Access Compliance Report

Public Rights-of-Way

(Curb Ramps)

Intersection ID: N/A	Main Street: WOODLAWN_ST	Cross Street: N/A	Location: N
ADA ID: 7366FC07DF27	Ramp Type: Perp	Initial Pass/Fail: Fail	Overall Compliance: No
			Severity Score: 13.75

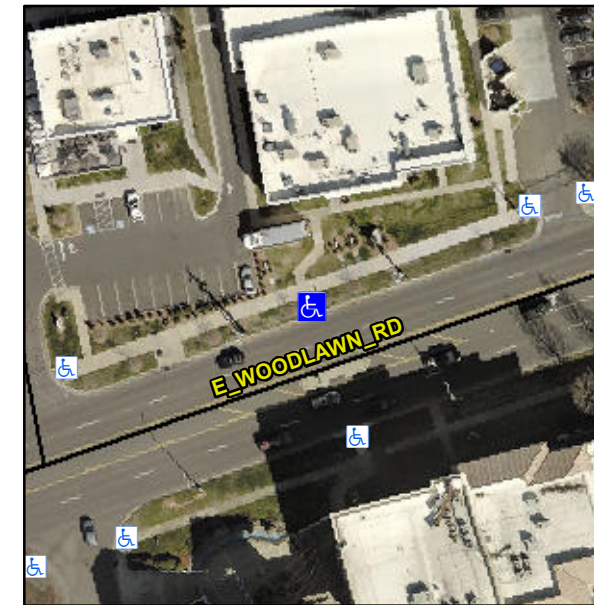
R304.2.2, R304.5.3

Compliance	Description	Data	Compliance	Description	Data
N/A	Ramp Length (in)	117.0	No	Ramp Slope (%)	8.8
Yes	Ramp Width (in)	69.0	No	Ramp XSlope (%)	4.8
N/A	Flare Type LT	N/A	N/A	Flare Type RT	N/A
N/A	Flare Slope LT (%)	N/A	N/A	Flare Slope RT (%)	N/A
N/A	Flare Traversable LT?	N/A	N/A	Flare Traversable RT?	N/A
N/A	Landing Length (in)	N/A	N/A	DWS Provided?	N/A
N/A	Landing Width (in)	N/A	N/A	DWS Contrast?	N/A
N/A	Landing Slope (%)	N/A	N/A	DWS Length (in)	N/A
N/A	Landing X Slope (%)	N/A	N/A	DWS Full Width?	N/A
N/A	Landing Curb? (Y/N)	N/A	N/A	DWS Offset (in)	N/A
N/A	Shared Landing?	N/A			
N/A	Gutter Ponding?	N/A	N/A	Gutter Slope (%)	N/A
N/A	Gutter Lip Ht (in)	N/A	N/A	Gutter X Slope (%)	N/A
N/A	Painted X Walk1?	No	N/A	Painted X Walk2?	N/A
	X Walk 1 Direction	To S		X Walk 2 Direction	N/A
N/A	X Walk 1 Width (in)	N/A	N/A	X Walk 2 Width (in)	N/A
	X Walk 1 Slope (%)	4.2		X Walk 2 Slope (%)	N/A
	X Walk 1 X Slope (%)	3.2		X Walk 2 X Slope (%)	N/A

Remove & Replace Entire Ramp.
